RISO, INC. **PARTS CHANGE INFORMATION**

PART: 6300 THERMAL HEAD HARDWARE **ISSUE #: 051**

Thermal Head Pressure

Modifications 1 & 2

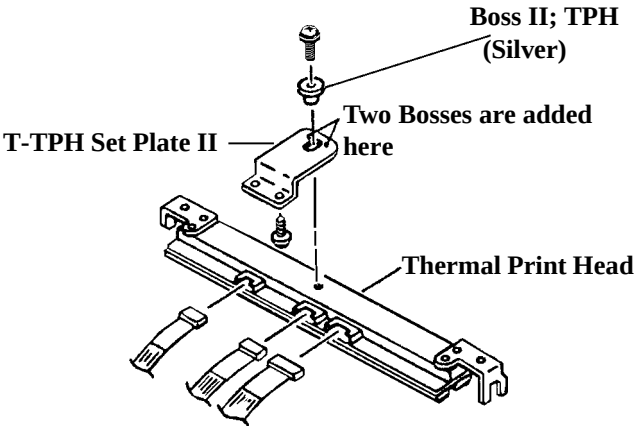
An enhancement to the Thermal Pressure Mechanism has been added to the current 6300 production. This change has been incorporated to reduce the possibility of uneven Thermal Print Head pressure.

Pressure Assist Plate II:	014 - 15022	T - TPH Set Plate II:	014 - 15025
Boss II:	014 - 15026	Spring; A3-TPH Pressure:	014 - 15027
